## ADDENDUM ONE

University of South Carolina

### CRF DM STEAM AND CONDENSATE LINE REPLACEMENT

Project Number: CP00336833 / H27-6094 - M

TREE PROTECTION FENCING (IN-GROUND) WITH SCREENING

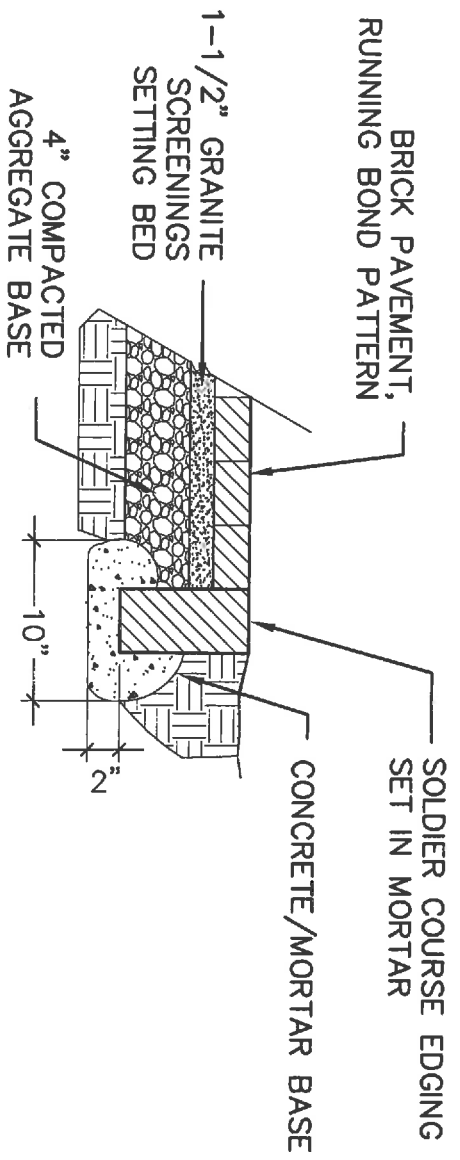
5. It is the contractor's responsibility to install any and all required tree protection both within the construction limits as well as on trees adjacent to the accessing route to and from Pickens Street. See tree protection detail attached.

1. PROVIDE PROTECTION FENCING FOR ALL TREES WITHIN AREA OF DISTURBANCE AND CONSTRUCTION ACCESS.
2. PROTECTION FENCING TO BE PLACED AT THE OUTSIDE OF THE CANOPY DRIPLINE, OR AT A DISTANCE OF ONE FOOT PER ONE INCH OF TREE DIAMETER, MEASURED AT BREAST HEIGHT, WHICHEVER IS LARGER, UNLESS OTHERWISE INDICATED ON LANDSCAPE PLAN OR APPROVED BY UNIVERSITY ARBORIST.

3. PROTECTION FENCING SHALL BE IN PLACE PRIOR TO BEGINNING CONSTRUCTION.
4. DAMAGE TO ANY TREES DURING CONSTRUCTION SHALL BE ASSESSED BY UNIVERSITY ARBORIST AND THE UNIVERSITY ARBORIST SHALL STIPULATE WHAT ACTION WILL BE TAKEN FOR REMEDIATION OF DAMAGE. THE COST OF ANY AND ALL REMEDIATION WILL BE ASSUMED BY CONTRACTOR AT NO ADDITIONAL COST TO THE PROJECT.

5. DISTURBANCE OF ROOT ZONE UNDER DRIPLINE OF TREE, INCLUDING COMPACTION OF SOIL, CUTTING OR FILLING OR STORAGE OF MATERIALS SHALL QUALIFY AS DAMAGE AND SUBJECT TO REMEDIATION.

6. VEHICLES, ANY PART OF WHICH ARE PARKED WITHIN OR PAST THE BOUNDARY OF THE TREE PROTECTION AREA, ARE SUBJECT TO TICKETING AND/OR TOWING. ("HANG TAGS" DO NOT PERMIT PARKING IN TREE PROTECTION AREAS.)

7. TREE PROTECTION FENCING SHALL BE CHAINLINK FENCING. ORANGE PLASTIC BARRIER FENCING IS NOT ACCEPTABLE AS TREE PROTECTION FENCING.
